Department of
Conservation and
Development

Contra Costa County

**Re: Comments on the Department of Water Resources' 2015 California WaterFix Section
404/10 Application
Public Notice SPK-2008-00861**

Attachment B**Contra Costa County Comments on WaterFix RDEIR/SDEIS****General Comment on the Inadequacy of All BDCP Alternatives**

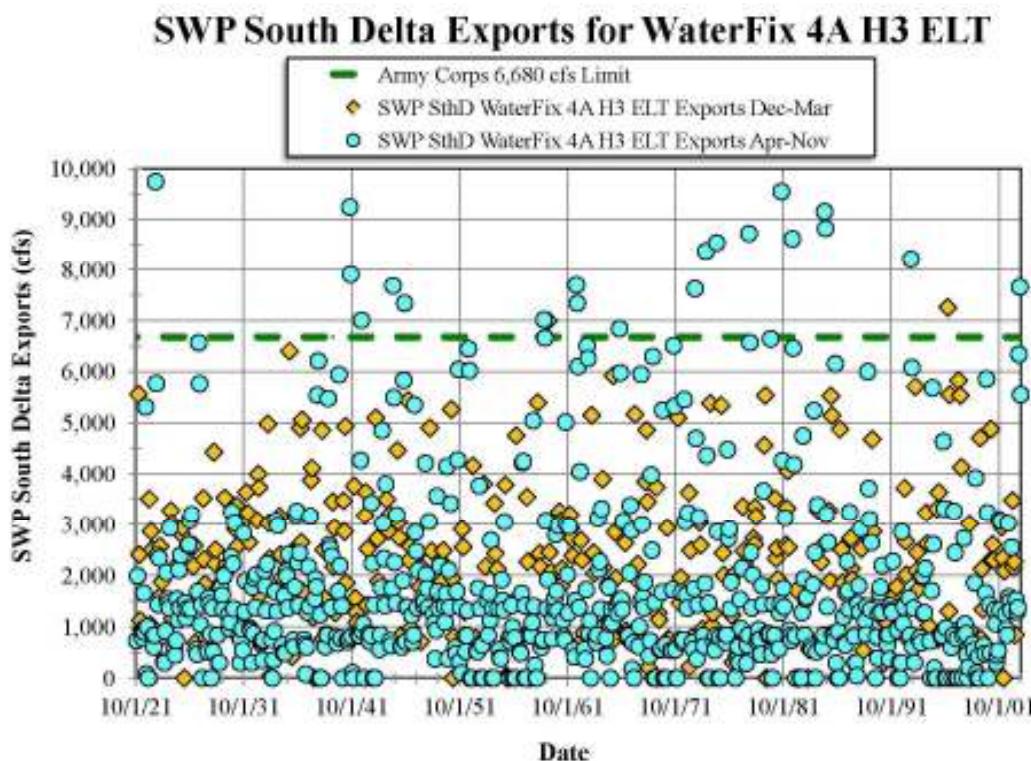
Figure 1 below shows the WaterFix analysis State Water Project (SWP) South Delta export data for Alternative 4A, Scenario H3, at early long term, for April through November when the USACE limits of 6,680 cfs apply. The simulated inflows to Clifton Court (SWP through-Delta exports) are as high as 9,750 cfs with total south Delta export as high as 14,350 cfs. This is well in excess of the permitted values for this period, and is inconsistent with the WaterFix project’s claim of reduced exports from the south Delta that contribute to ecosystem benefits.

Figure 2: Monthly SWP exports from the south Delta as a function of Delta outflow for the WaterFix preferred alternative (Alternative 4A, Scenario H3 at Early Long Term). There are many exceedances of the USACE limit on inflow to Clifton Court. They occur during periods of lower Delta outflow.

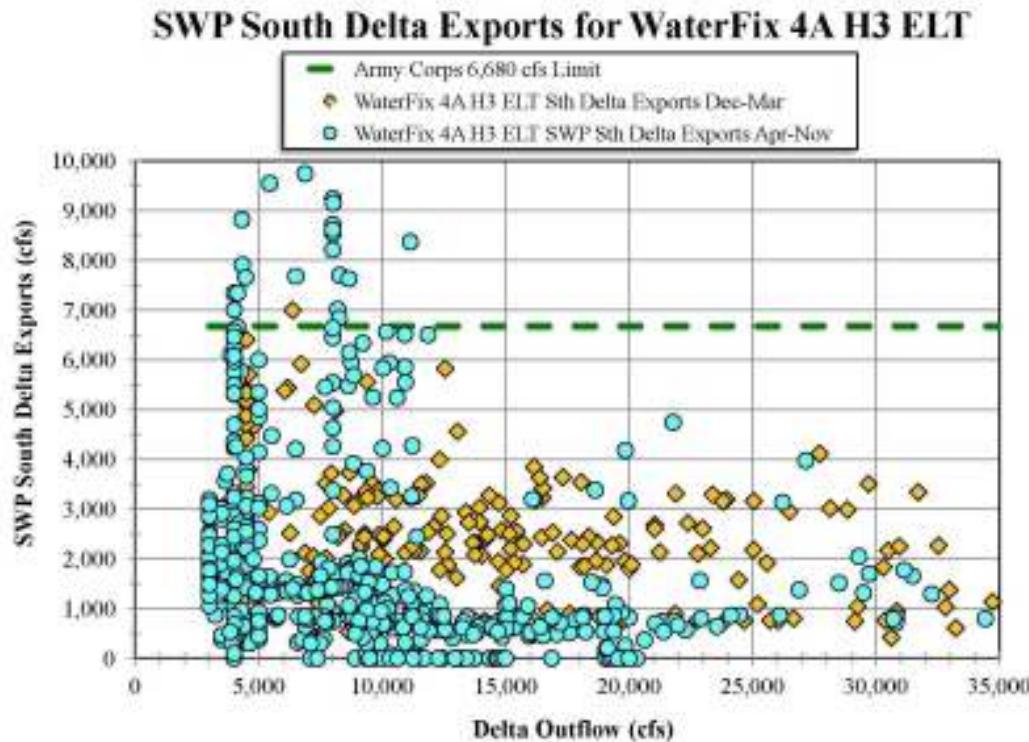
Figure 2 shows the same SWP south Delta export data as Figure 1, but this time plotted as a function of Delta outflow. The violations of the USACE limits occur during drier months when Delta outflows are lower. This is again directly contrary to the principle of taking a “Little Sip” during drier periods, *i.e.*, reducing exports relative to existing levels.

DWR's August 24, 2015 application to the USACE should have been, and still should be, rejected with the request that a new Draft EIR/EIS is prepared that includes new alternatives that comply with the U.S. Army Corps of Engineers limits on inflow to Clifton Court Forebay, and other legal requirements set by the SWRCB and the biological opinion. As discussed in detail in the U.S. Environmental Protection Agency's (EPA) October 30, 2015 comments on the RDEIR/SDEIS (Attachment 2), Endangered Species Act (ESA) Section 7 consultation with U.S. Fish and Wildlife Service and National Marine Fisheries Service regarding the construction and operation of new conveyance facilities is underway but not complete. Additional information is being generated to identify criteria for operating the new WaterFix facilities, to be included in the Biological Opinions and Incidental Take Permits. EPA stated that "*this information and such operating criteria could result in environmental impacts that have not been analyzed in the SDEIS.*"

Figure B-1: Daily EC values at Barker Slough from the sensitivity analyses for the period October 1976 through September 1984.

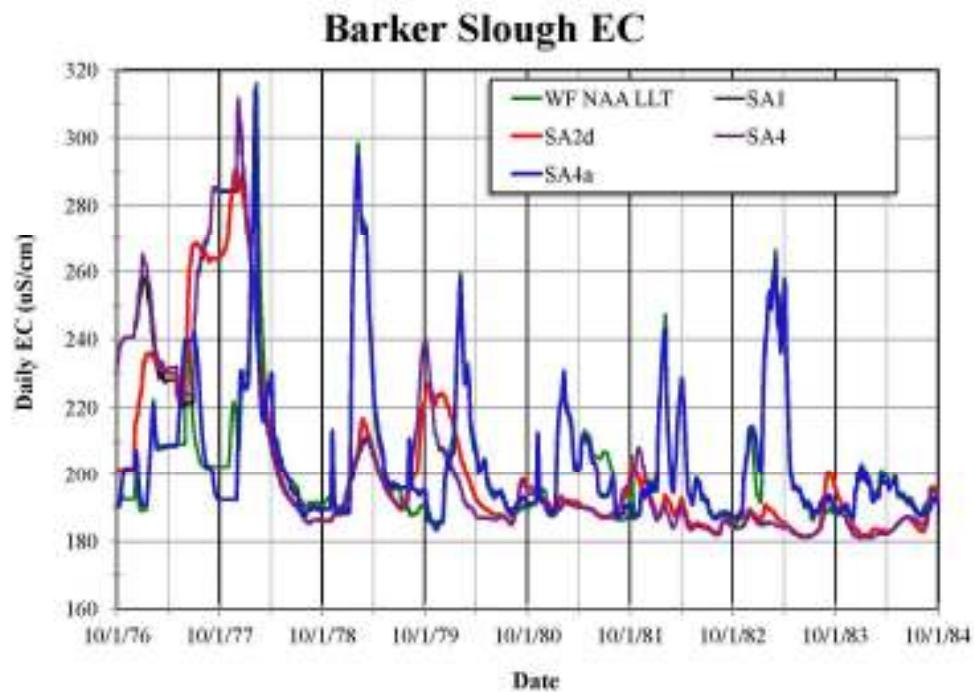
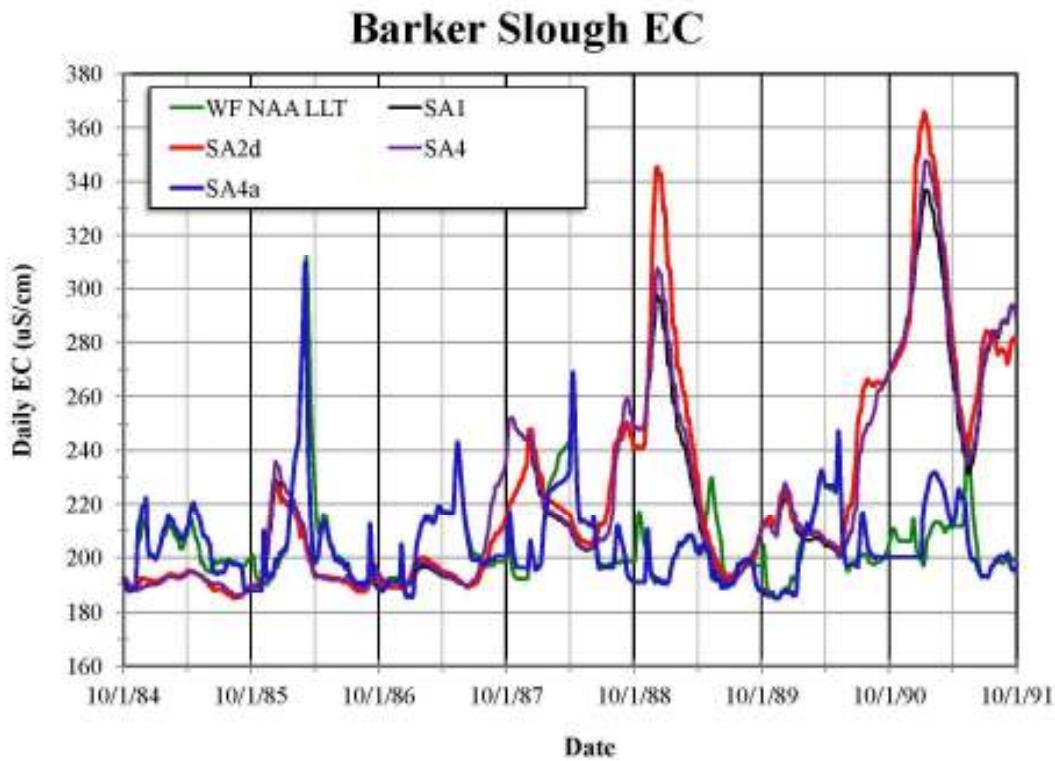
The Sensitivity Analyses were based on the flawed modeling for Alternative 4, Scenario H3 at late long term, i.e., 2060 conditions with habitat restoration, and were not updated using the most recent versions of the CALSIM II and DSM2 models. Figures B-1 and B-2 show the range of EC at Barker Slough for some of the sensitivity analyses:

As shown in Figure B-1 and Figure B-2, removing the 65,000 acres of habitat restoration could reduce EC at Barker Slough during drought periods (relative to the BDCP Draft EIR/EIS proposed project, SA1) but increases EC significantly in normal and wetter years.

Figure B-3: Scatter plot of daily EC values at Barker Slough from the WaterFix sensitivity analyses with no restoration (SA4a, LLT) for the period October 1975 through September 1991. Some peak EC are reduced relative to the No Action equivalent but significant adverse impacts occur at other times.

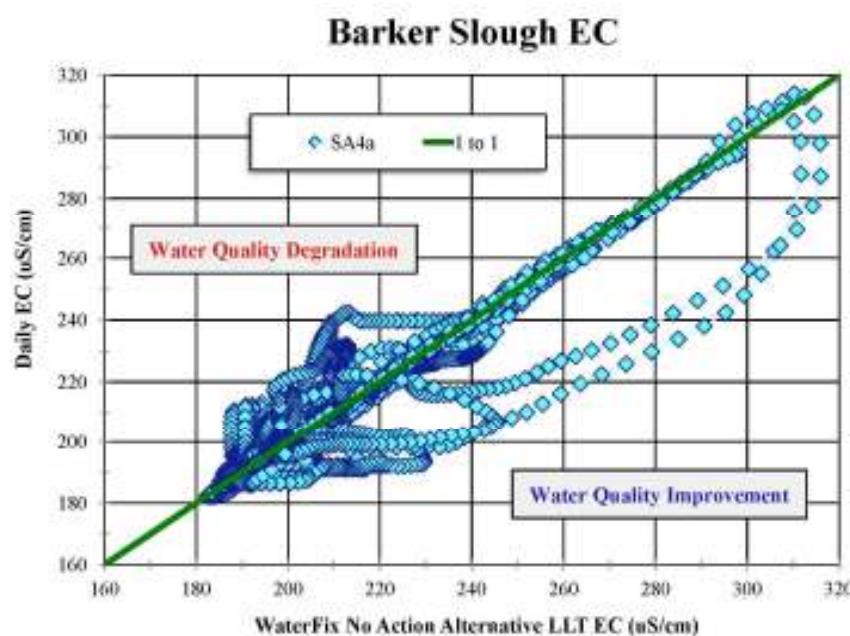
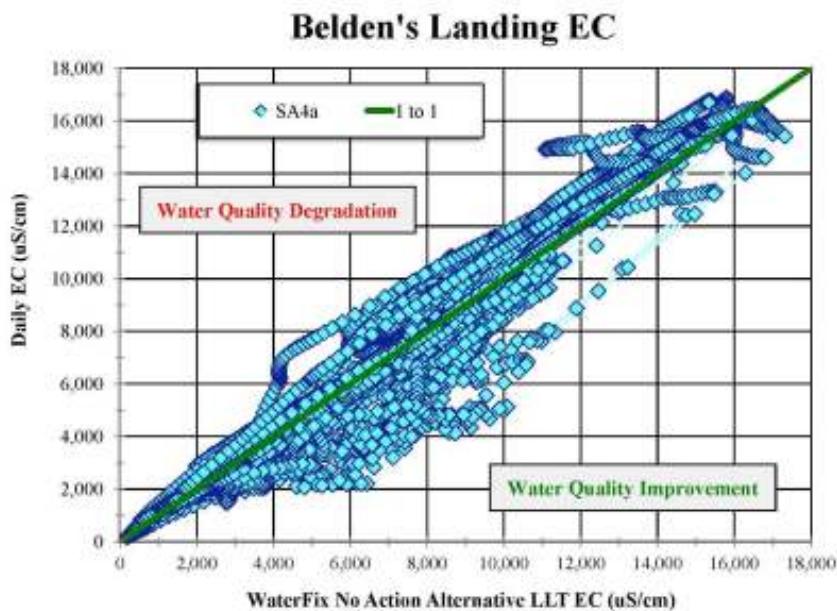
Figures B-3 and B-4 show the EC data for each month of the 16-year sensitivity analysis simulation period (192 data points) in the form of scatter plots. The EC data for Barker Slough and Belden's Landing for Sensitivity Analysis #4 (no habitat restoration) are plotted as a function of the WaterFix No Action Alternative and both are at late long term.

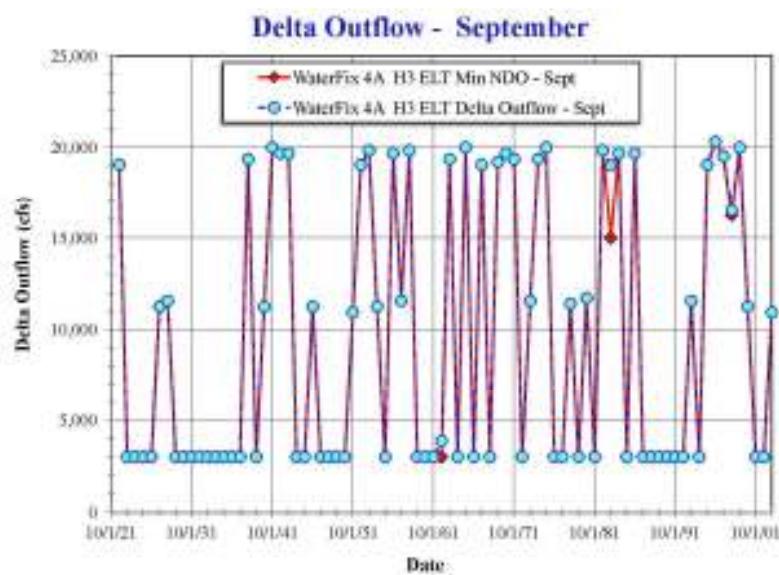
The outflows required to meet the Fall X2 requirement in September and October in the WaterFix analyses using CALSIM II, however, are very much larger. As shown in Figure B-5, the assumed minimum Delta outflows to meet X2 at Mallard Island (in wet years) and Collinsville (above normal years) are about 19,500 cfs and 11,500 cfs, respectively. These flows seem to be too high and may be artificially freshening the Delta during September and underestimating the water quality impacts of the proposed project. The reason for these high flows may be because the CALSIM II only attempts to meet September X2 requirements at the last minute, whereas increasing Delta outflows earlier will require much less Delta outflow.

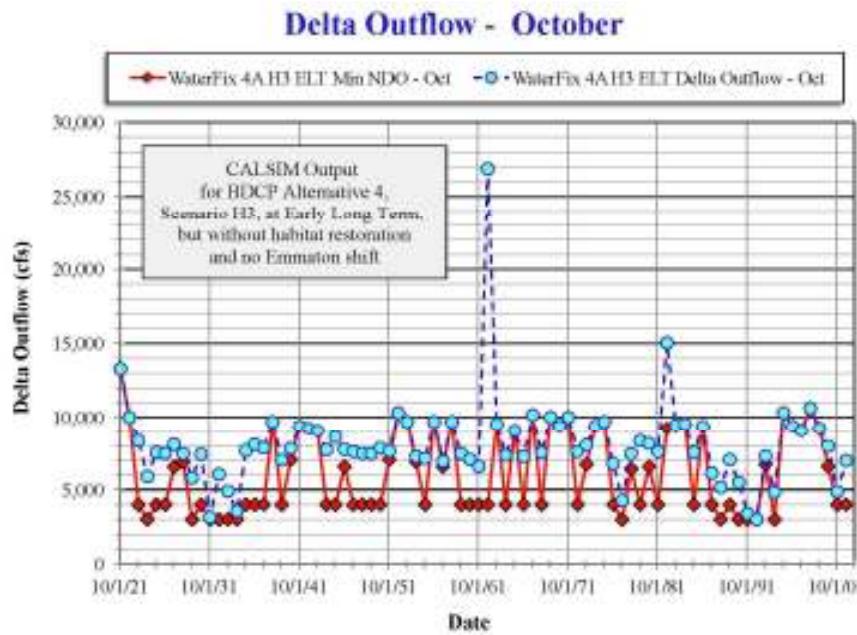
Figure B-6 shows the corresponding Delta outflows and minimum required Delta outflows for October. The October outflows are governed by the need to meet Fall X2 in wet and above normal years. Otherwise the D-1641 requirement of 3,000 cfs in critical years and 4,000 cfs in other water years applies. The flows assumed to be required to meet Fall X2 are consistent with the existing X2 outflow requirements. However, excess Delta outflows are occurring in many below normal, dry and critical years, which may underestimate the actual water quality impacts of the proposed project.

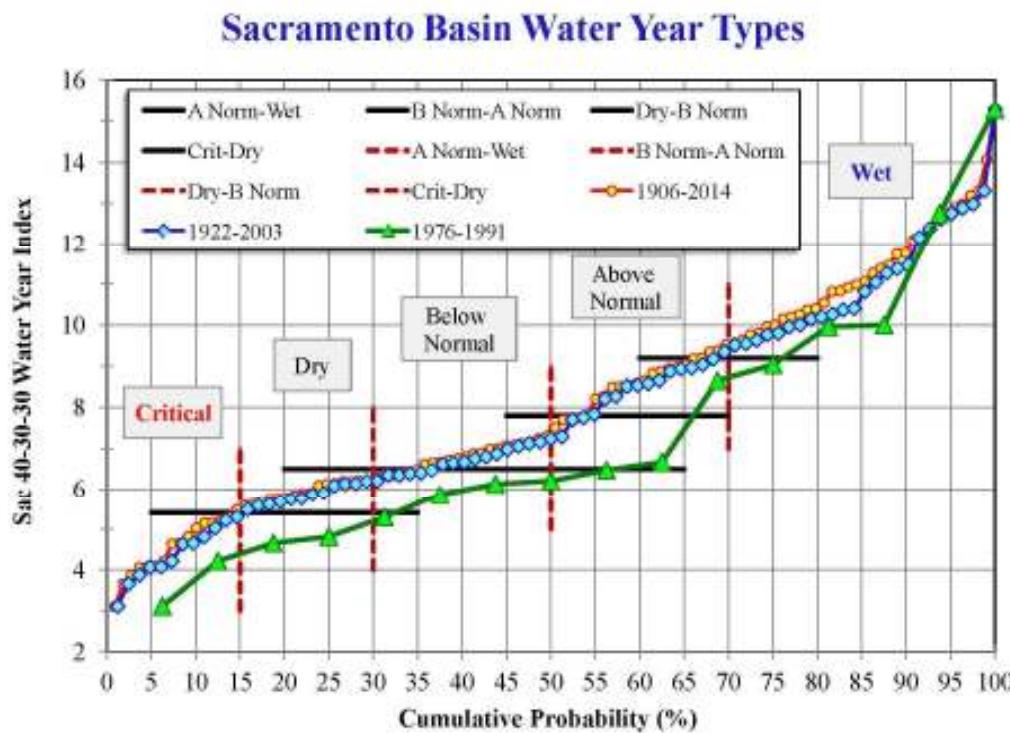
Also as shown in Figure B-7, the water year 1976-1991 period is considerably drier than the full historical record (1906-2014) and the 1922-2003 period used for the Central Valley operations modeling using CALSIM II.

Figure C-1: Monthly total Delta exports as a function of Delta outflow for the WaterFix preferred alternative (Alternative 4A, Scenario H3 at Early Long Term). Only months when outflows are less than 30,000 cfs are plotted.

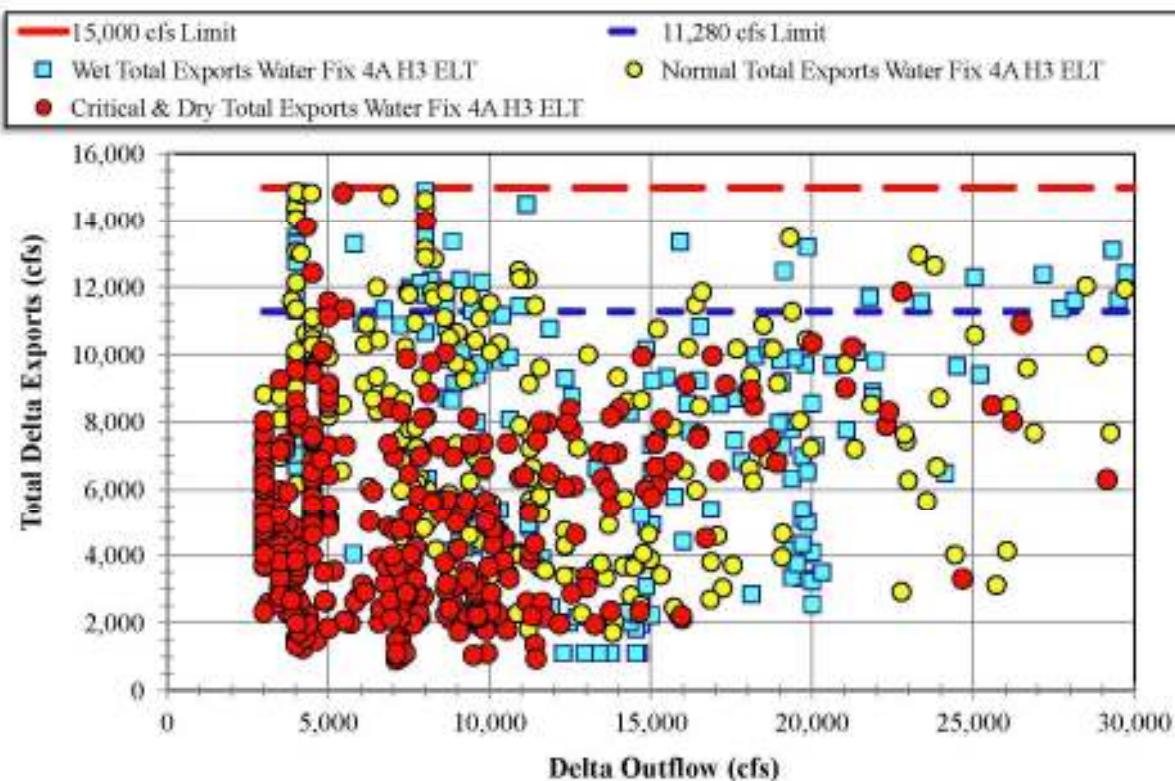
Currently, the maximum rate of exports from the Delta during drier periods is about 11,280 cubic feet per second (6,680 cfs at the SWP export facility plus 4,600 cfs at the CVP pumps.). As shown in Figure C-1, the WaterFix data for Alternative 4A, Scenario H3 at early long term, suggest that in many dry months when Delta outflows are very low, the combined SWP and CVP exports from the south Delta would be as high as 14,900 cfs. This is an increase in south Delta pumping of 3,600 cfs or about 24%.

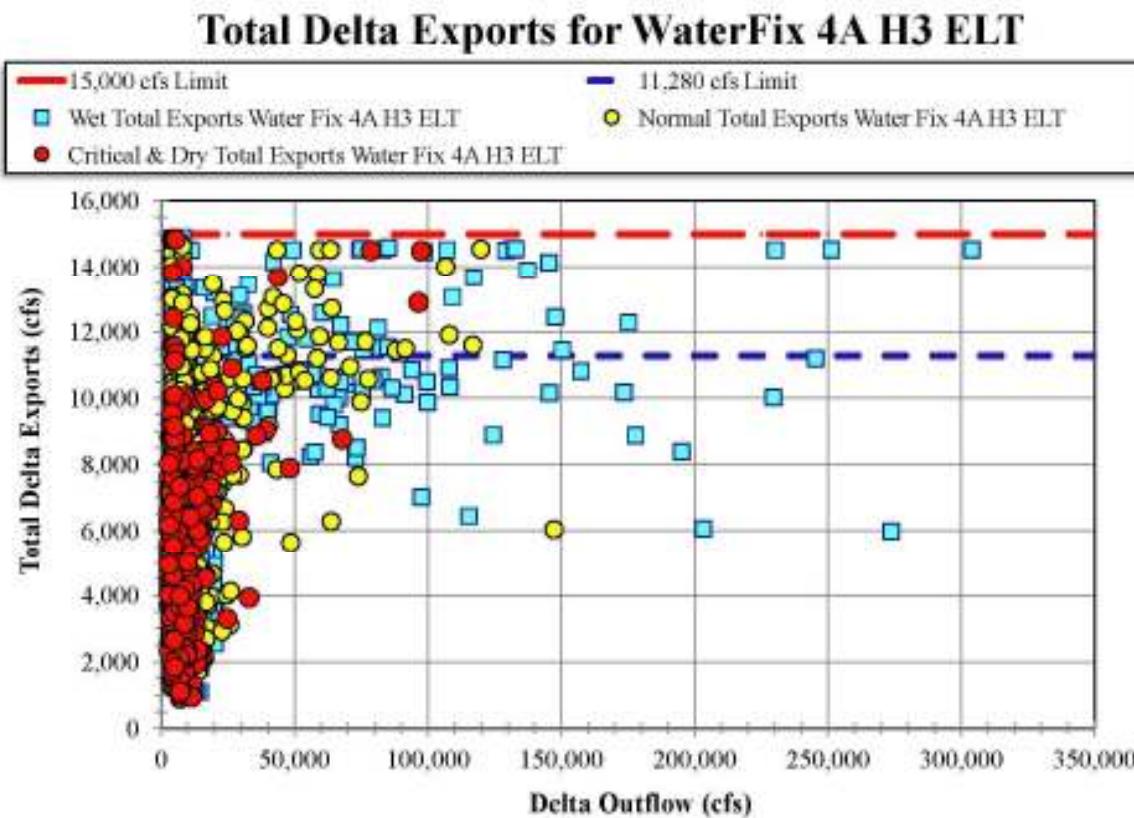
The same WaterFix operations simulations show that during periods of high Delta outflow (say 30,000 cfs or greater), when water surplus to the needs of the Delta could be available for export, the WaterFix preferred alternative often fails to increase in export diversions above existing levels (Figure C-2). In other words, without new storage in or close to the Delta, the WaterFix preferred alternative is unable to capture this surplus flow. During wet periods, farmers' fields and urban landscapes are soaked reducing demand for water. The existing south-of-Delta reservoirs fill and there is nowhere else to quickly store the more water. The WaterFix preferred alternative will be unable to regularly take a "Big Gulp."

Increasing exports from the Delta in the dry months is in direct conflict with the 2009 Delta Reform Act (Water Code Section 85021), which states that the policy of the State of California is to reduce reliance on the Delta in meeting California's future water supply needs through a statewide strategy of investing in improved regional supplies, conservation, and water use efficiency. The BDCP proposed project includes no actions to improve regional self-reliance for water through investment in water use efficiency, water recycling, advanced water technologies, local and regional water supply projects, and improved regional coordination of local and regional water supply efforts.

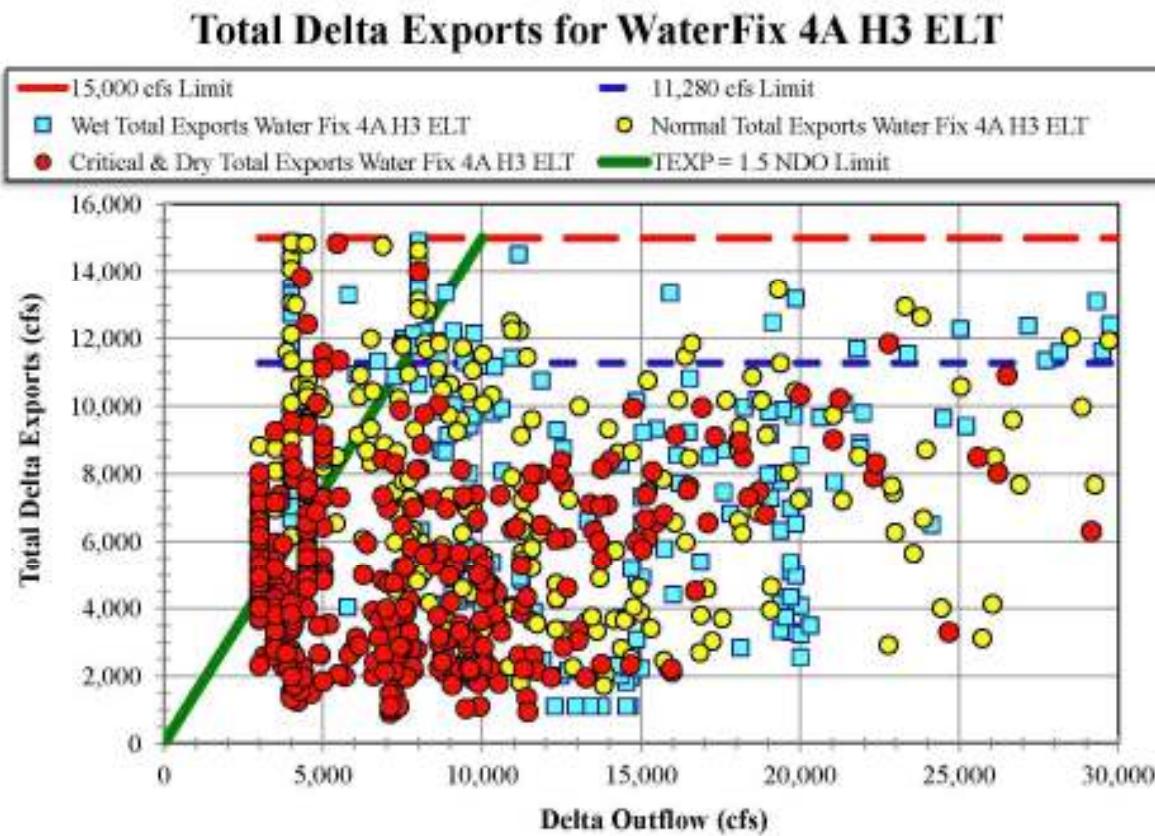
Figure C-3 shows the same data as Figure C-1 but this figure also shows a limit on total CVP and SWP exports of the form: total exports = 1.5 x Delta outflow.

This would mean that in the fall when outflows are only 3,000 cfs, only 4,500 cfs can be exported. The CVP and SWP would not be able to increase exports above existing levels unless Delta outflow was 7,500 cfs or greater. The resulting loss of export water would have to be made up during periods of higher Delta outflow. That will not be possible though without new storage and other infrastructure in the Delta to capture more water during higher flow periods.
